**RE: Cutler Right-of-Way Dedication  
Master Drainage Plan  
Engineer's Stamp Date: 07/15/21  
Hydrology File: H17D036**

Based upon the information provided in your submittal received 07/15/2021, the Master Drainage Plan is **not** approved for Work Order and for action by the DRB on Preliminary Plat. The following comments need to be addressed for approval of the above referenced project:

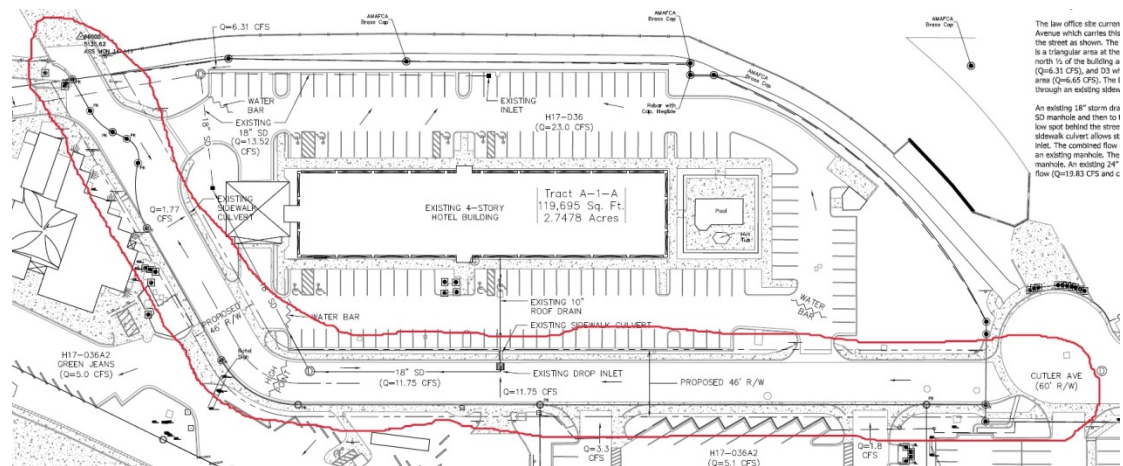
1. Please provide a Grading Plan with enough grades for the Work Order. (please see image below)

2. Please verify the pipe size, material of the existing storm sewer. Also please provide the rim elevation of the manholes, pipe inverts, inlet rim elevations. This will be needed to determine if these need to be replaced and added to the Infrastructure List., and get grate elevation.
3. Also please include any changes that will be done for the Work Order on the Grading Plan. For example, at the cul-de-sac the road will be flattened and straightened. (please see image below)

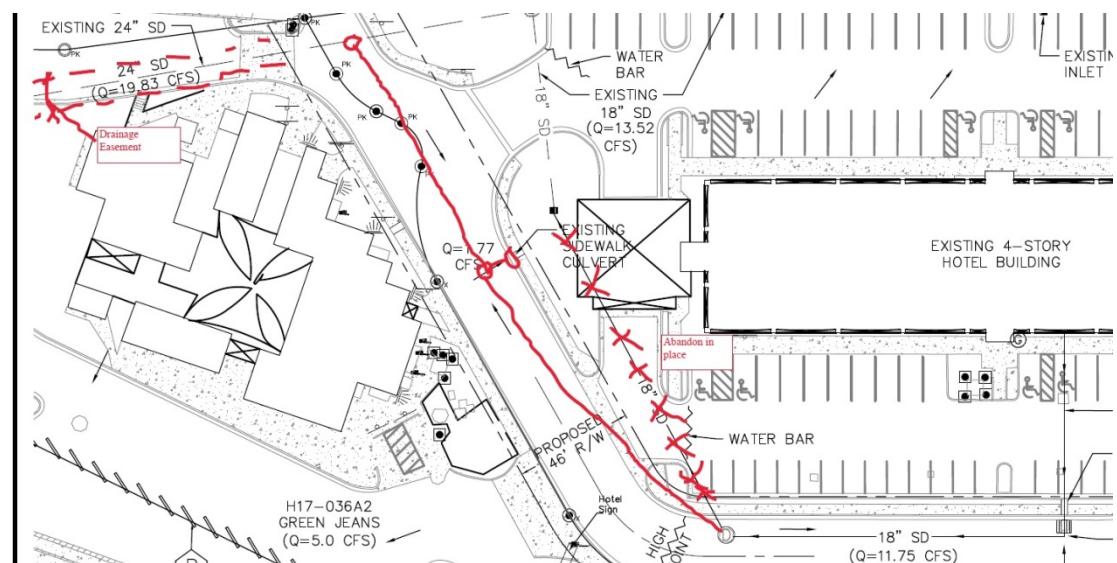
4. Question – Are the storm sewer going to be maintained by the City or by the private development?
5. Question – Are all drives going to be brought to City standards (COA Drawing 2425A)?
6. Question – Is the roadway staying as an elevated road? Is this road have a 2% max cross slope? Or is the roadway going to have a crown in the middle?
7. If the answer to #4 is that the City is going to maintain the storm sewer, Then I suggest that an inlet be installed at the sump on the west side of the project area and that a new pipe is installed along with a new manhole. Then the existing pipe on the Green Jeans property will have be placed in a Public Drainage Easement. (See image below)

# MASTER DRAINAGE PLAN

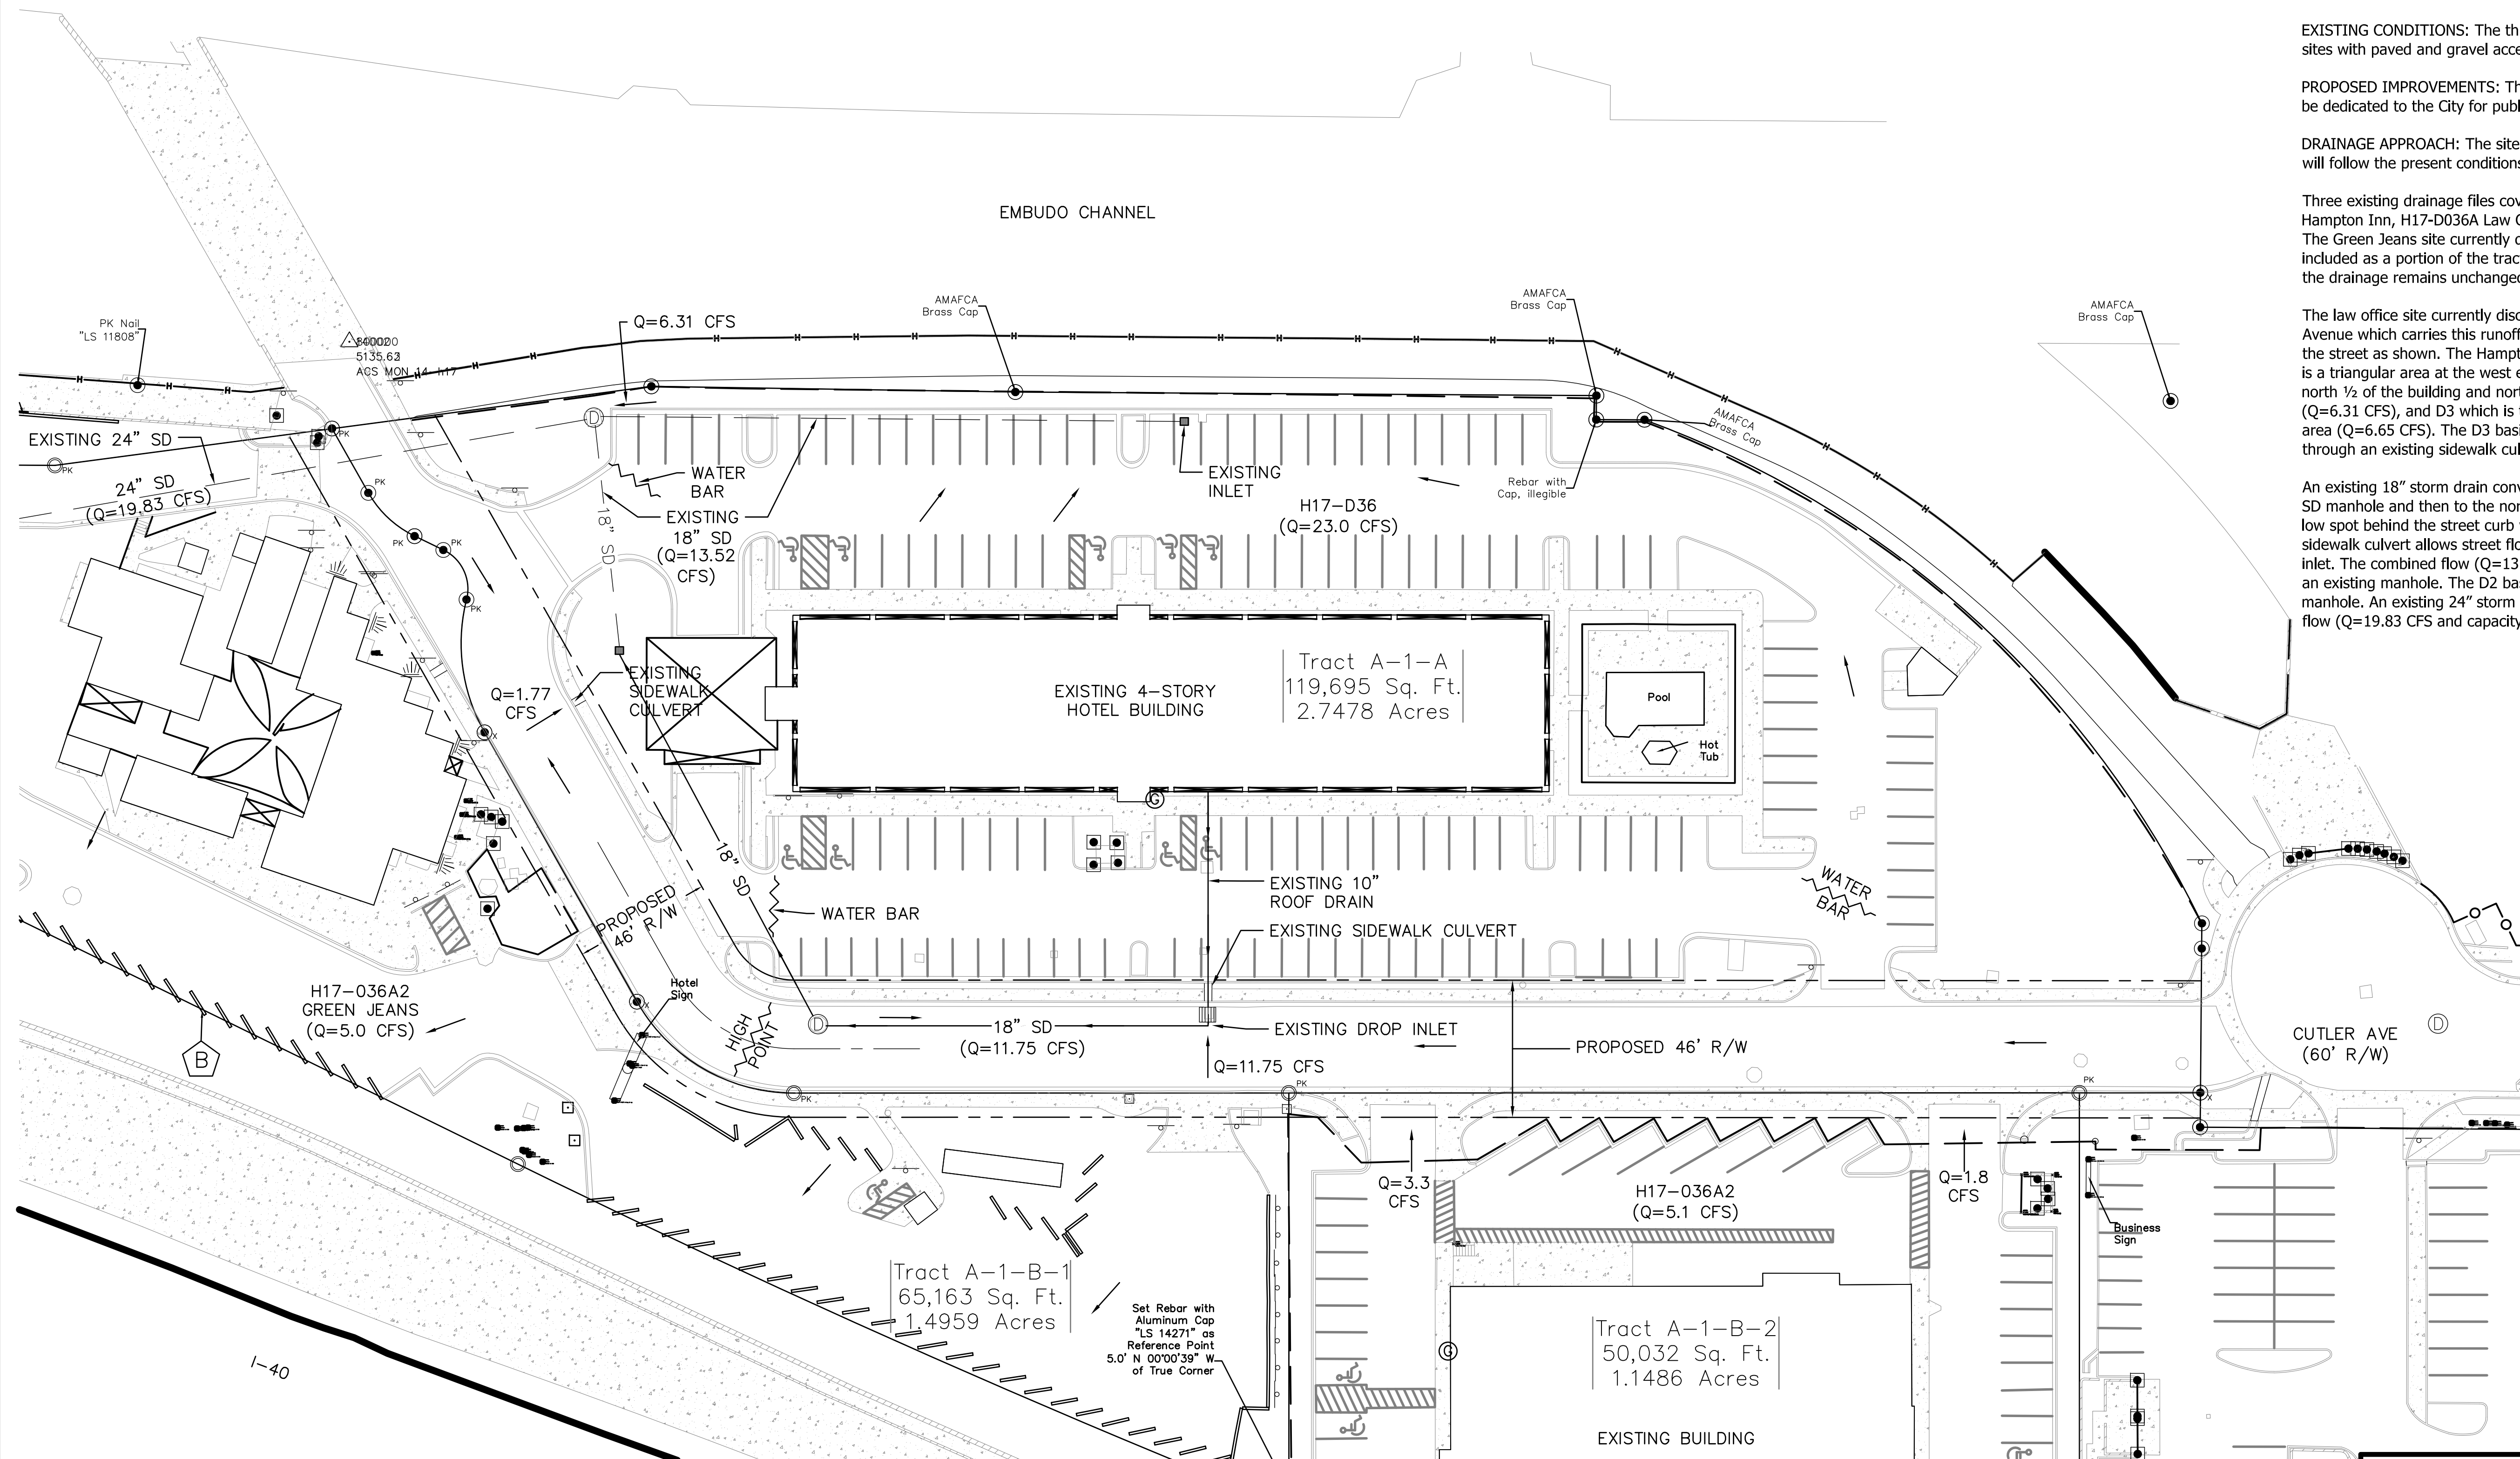
8. Master Drainage Plan. Please show where the storm pipe connects to the DOT inlet and then discharges into the Embudo Channel.
